SERVICE BULLETIN

TITLE: LANDING GEAR - REPLACEMENT OF NOSE GEAR TRUNNION CHAMFERED WASHERS

Figure 1
Nose Gear Trunnion Hardware Location

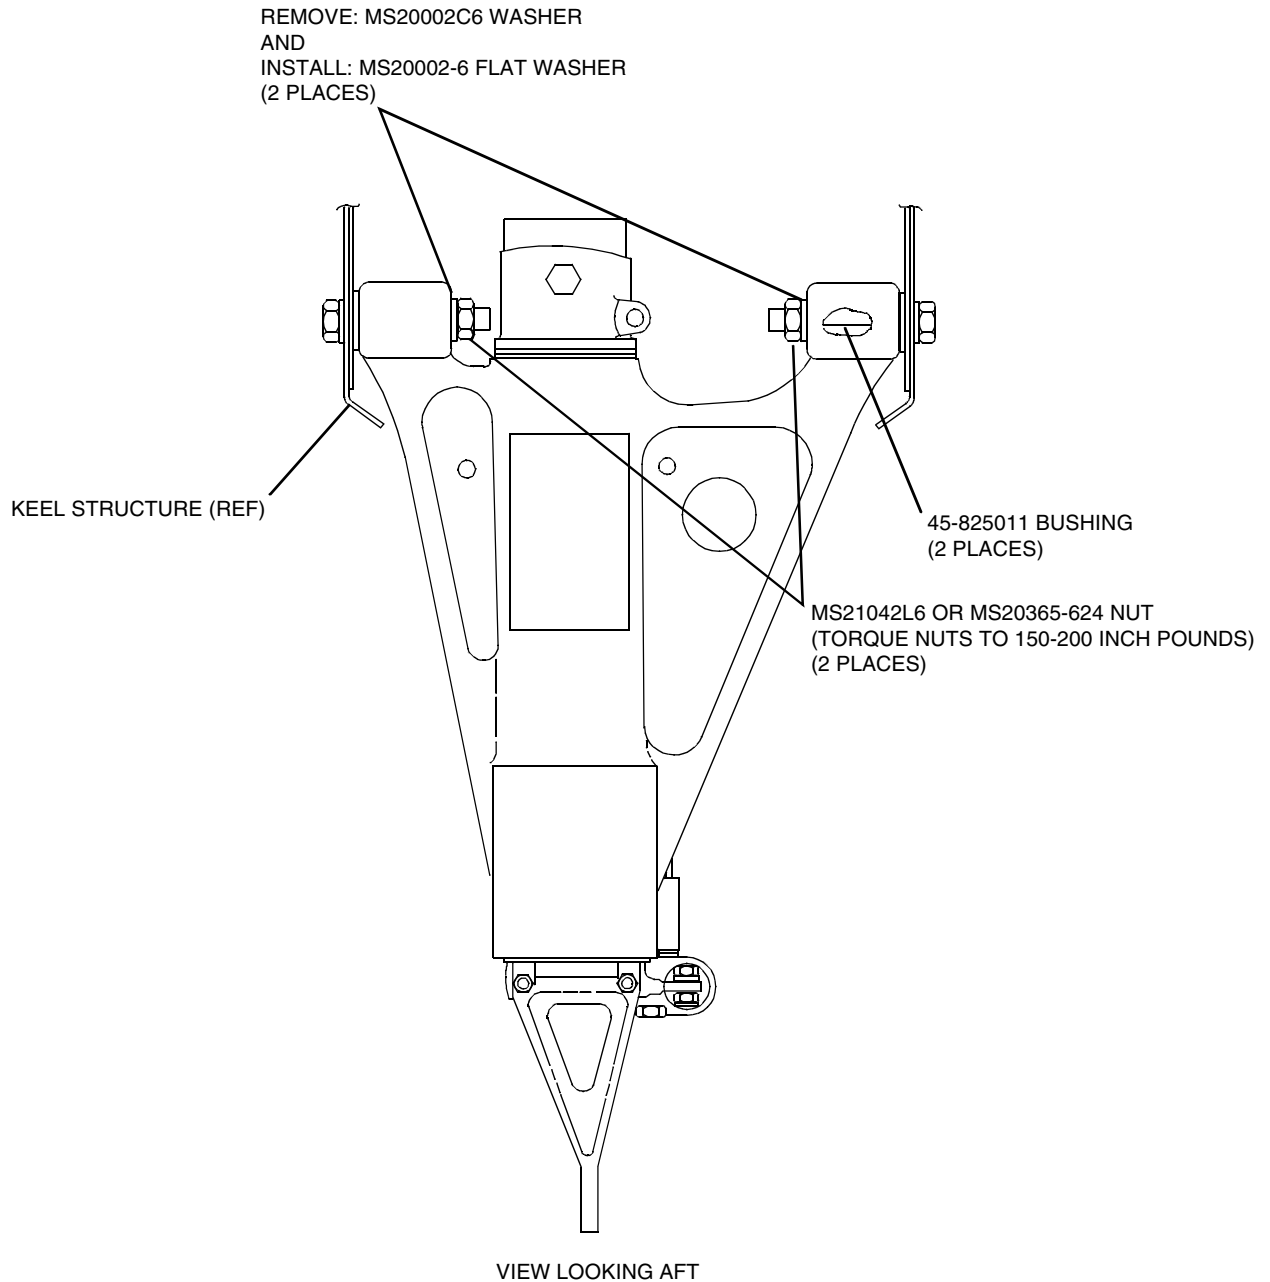
This Service Bulletin is being issued because Raytheon Aircraft Company (RAC) has received reports of landing gear trunnion nuts not maintaining proper torque when the chamfered washer was not properly installed.

This Service Bulletin provides instructions to remove existing P/N MS20002C6 chamfered washers and replace with P/N MS20002-6 flat washers under the MS21042L6 or MS20365-624 nut.

- (3) Remove and discard the P/N MS21042L6 or MS20365-624 nut from the nose gear trunnion and inspect the P/N MS20002C6 chamfered washer to see if the countersunk side is facing toward the nut. Refer to Figure 1 for the locations of nose gear trunnion hardware.

- (a) If the countersunk side of the washer is facing toward the nut, replace with P/N MS20002-6 flat washer. Install new P/N MS21042L6 or MS20365-624 nut and torque to 150 - 200 in. lbs.

- (b) If the countersunk side of the washer is not facing toward the nut, replace P/N 45-825011 bushing with new bushing in accordance with Bonanza Series Maintenance Manual, Chapter 32. Install P/N MS20002-6 flat washer. Install new P/N MS21042L6 or MS20365-624 nut and torque to 150 - 200 in. lbs.
